Agenda Item 8

Application No. P17/S1599/RM

## Appeal Decision

**Appeal Ref: APP/Q3115/W/16/3161199**

**Title:** Block plan with Parking, Vision Splays and landscaping details

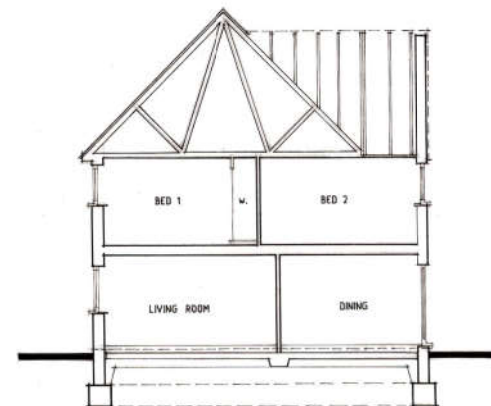
5. The landscaping scheme does not accord with the proposed block plan inasmuch as the parking arrangements for the westernmost unit are different. This minor discrepancy could be addressed by the submission of a revised landscaping scheme, which could be secured by planning condition in the event that the appeal was allowed.

10. I have no reason to doubt that retention of the hedge is feasible, but differences in ground levels inevitably mean that the land at the edge of the appeal site would need to be banked upwards to protect the tree roots. This would take up a proportion of the rear garden depth and thereby restrict the amount of usable garden, particularly for the easternmost unit. To my mind, the proximity of the houses to the boundary at the narrowest part of the site would give the development an uncharacteristically cramped appearance which would be noticeably at odds with the altogether more spacious pattern of development in the cul-de-sac as a whole.
